Fwd: Permit application 54 Ninth Street

From: **Brian Bouchard** <boubbin1@gmail.com>
Date: Wed, Jul 6, 2016 at 1:28 PM
Subject: Re: Permit application 54 Ninth Street
To: Jennifer Thompson <jlt@portlandmaine.gov>

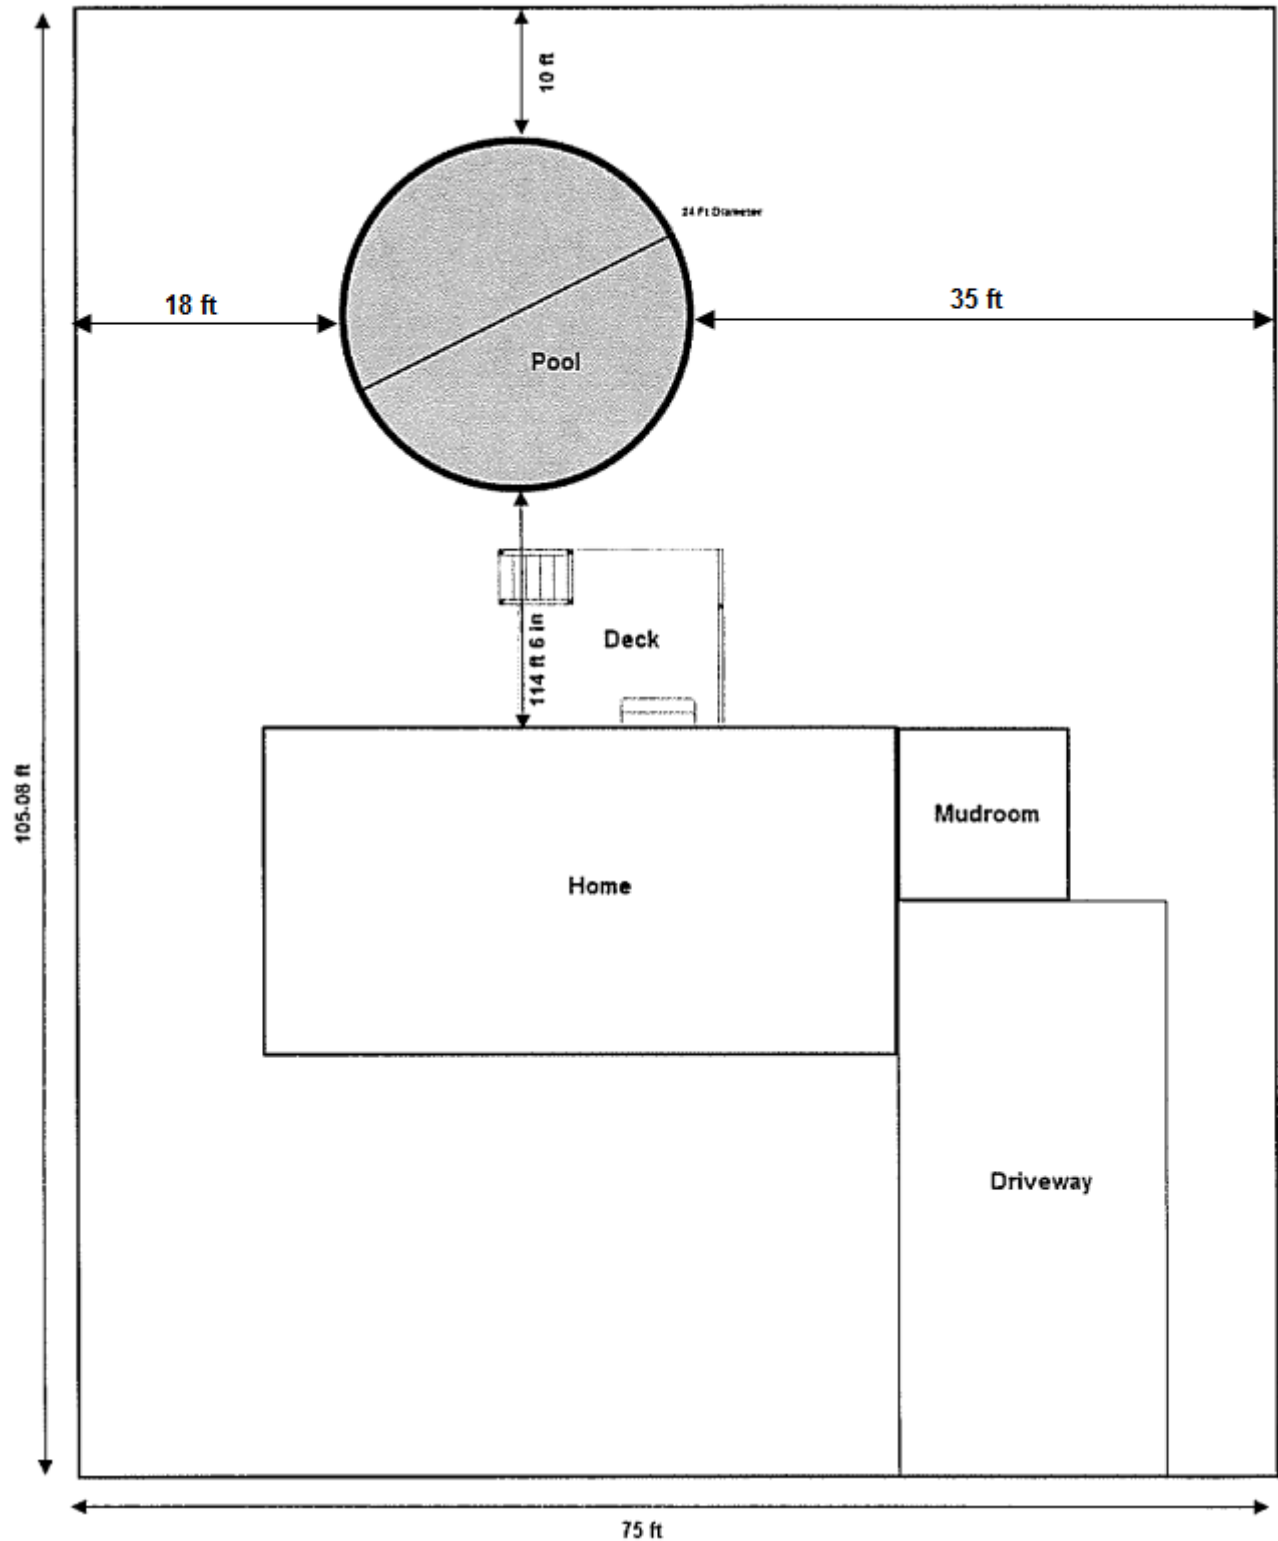
Thanks, Brian. This is helpful. I assumed there was sufficient distance but because the measurements on plan you sent aren't to scale, this confirmation will be helpful for our records. I appreciate your quick response.

I am in the process of reviewing your application to place an above-ground pool at 54 Ninth Street. As you are likely aware, the City of Portland's zoning code requires that pools be located at least 10 feet from both the rear lot line and the side lot lines. The plan you submitted in support of your application depicts the setback from the rear lot line but I can't tell how far away from the side lot lines the pool will be. Can you please send along those measurements so I can determine whether your application meets the City's code requirements?

My apologies Jennifer. I probably neglected to provide that info because the distance from the left and right side is quite a bit over 10 ft from the property line. The distance on the left side is 18 feet and the right side is 35 feet. I updated the picture in case you need that as well to replace the original.
